W: 43 Croton Dam Road ARB Planning Consultant Comments

Here is a list outlining some outstanding items in your application based on the ARB checklist. The deadline for revisions for returning applicant is February 1st. If the following outstanding items are submitted, you may be placed on the agenda for the February 21st Planning Board/ARB Meeting:

SECOND FLOOR PLAN

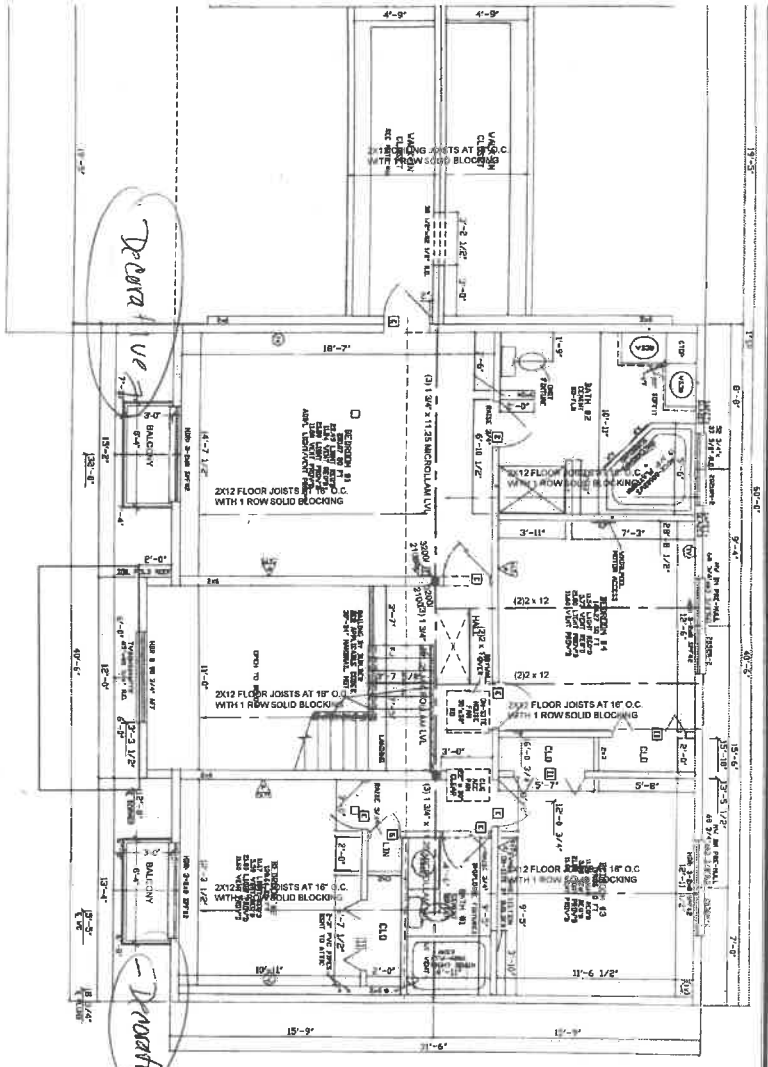
- Indication of if the parking is on the exterior.
- ✓ 4. On Sheet A-102:
 - Indication of if the balconies are decorative or actual.
- ✓ 5. An indication of existing and proposed freestanding and building-mounted exterior lighting adequate to determine their features and illumination and to enable review of possible hazards and disturbances on and off site, in the form of a lighting cut sheet.

Fence #7

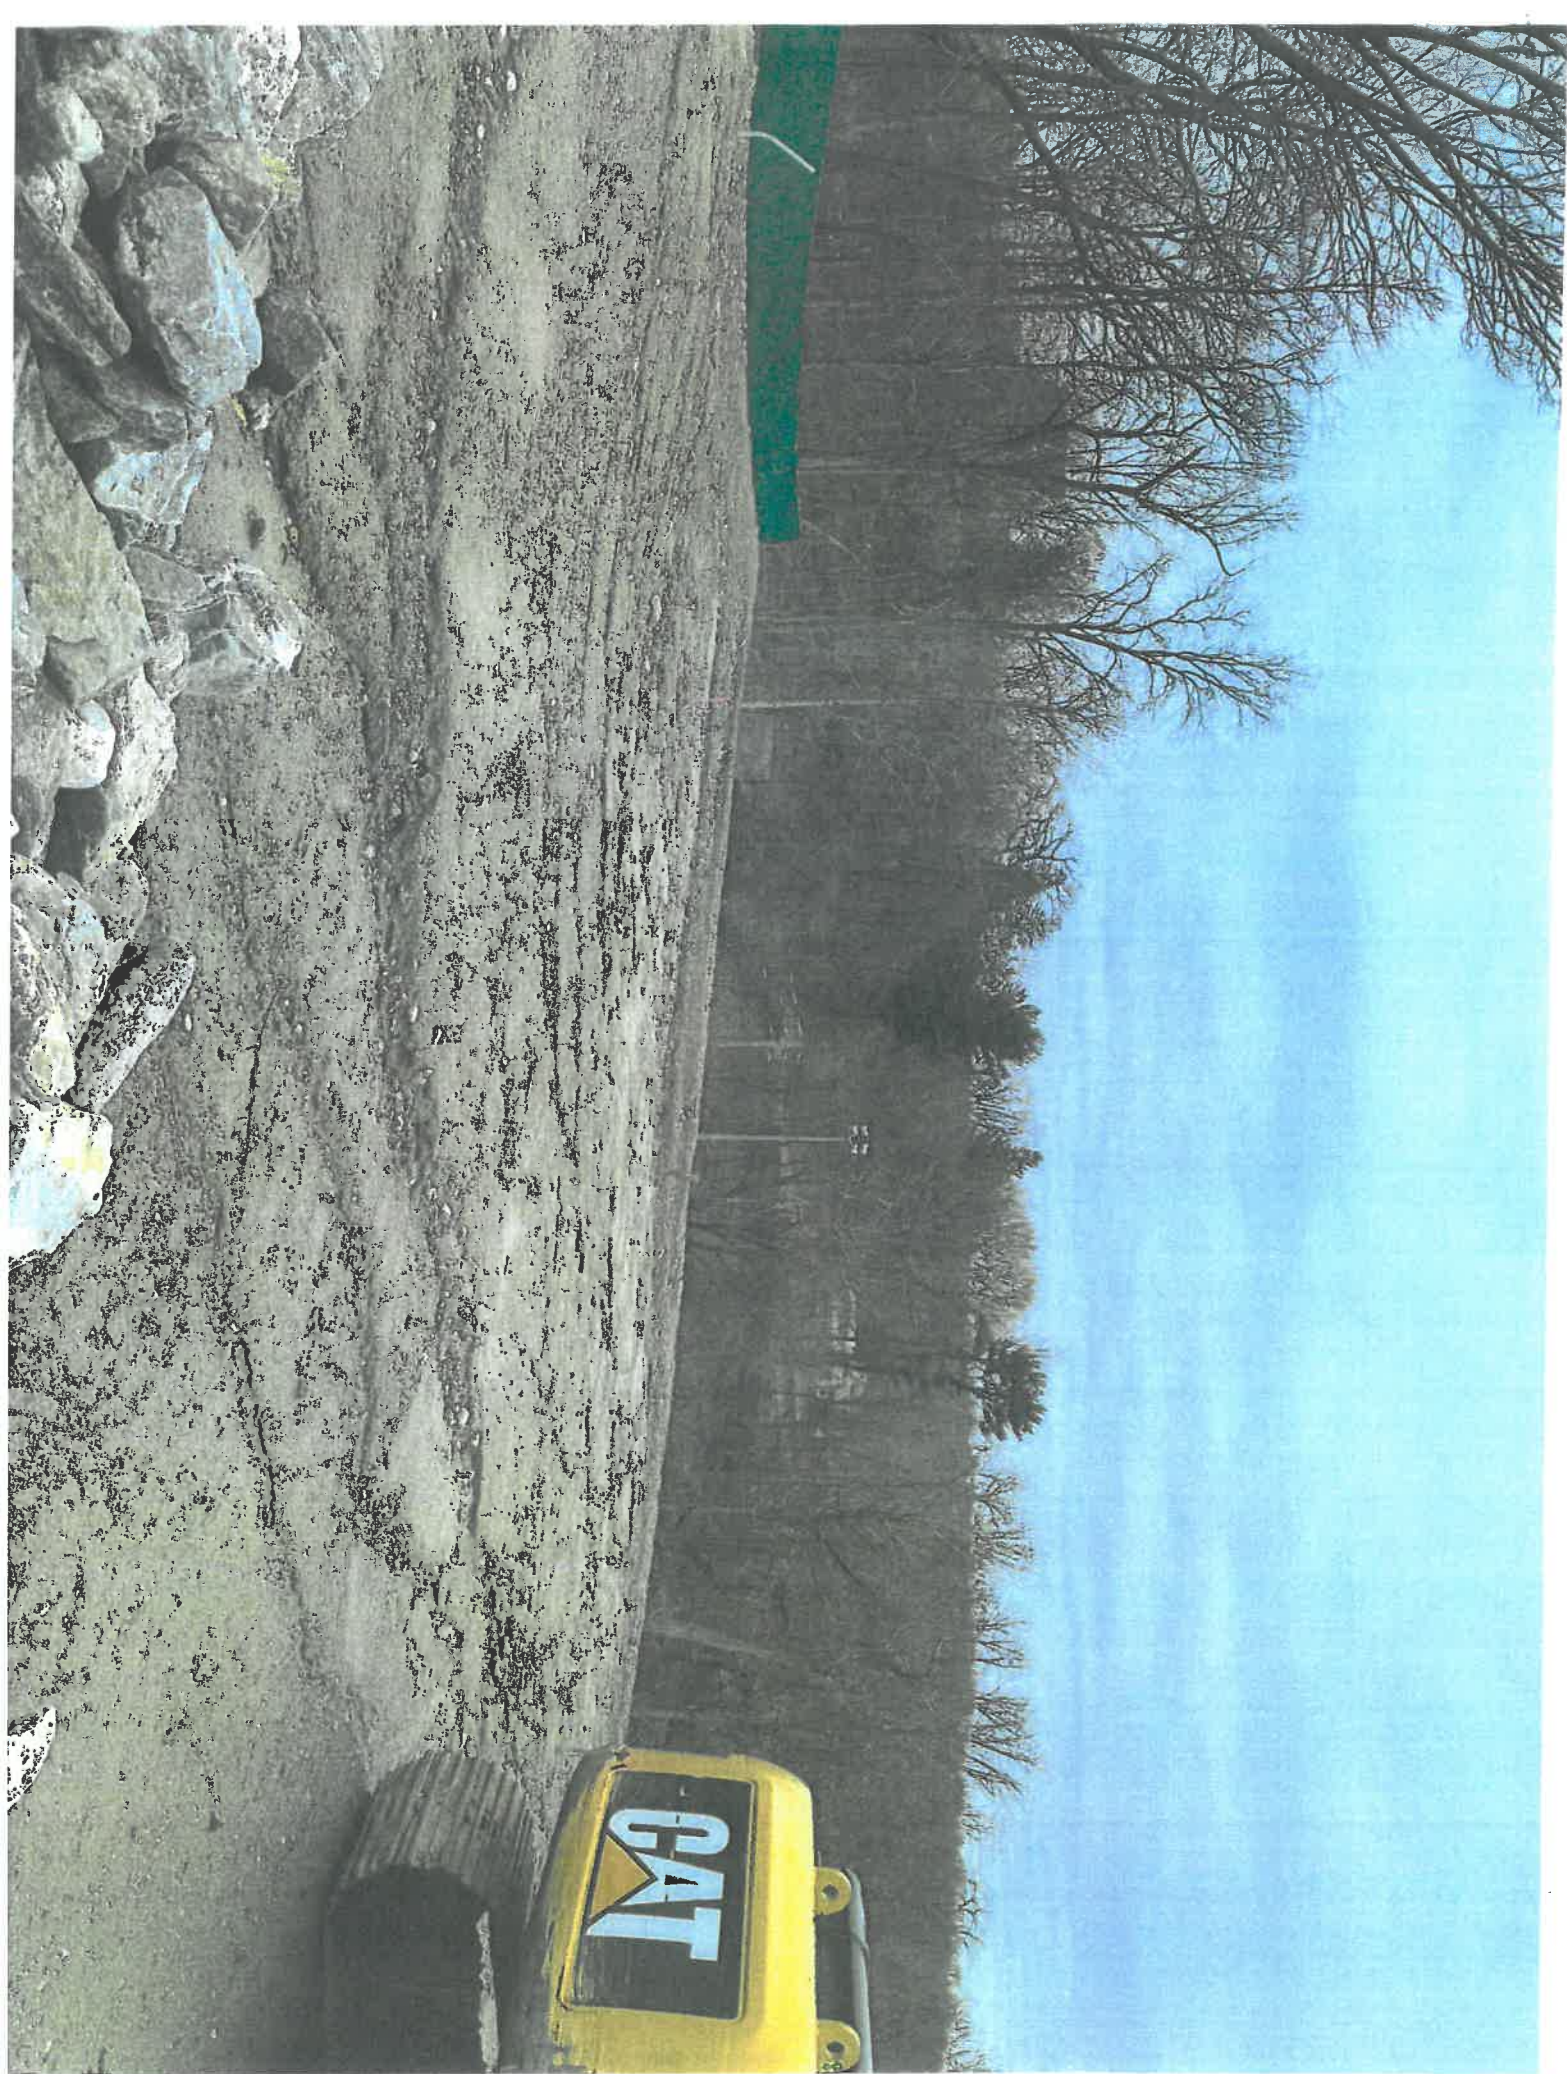
- ✓ 6. Photographs of the subject lot and of buildings and structures within 350 feet of said lot. Location map and street view.
- ✓ 7. Samples of all exterior building materials, treatments, and finishes, including that of the fence and the following:
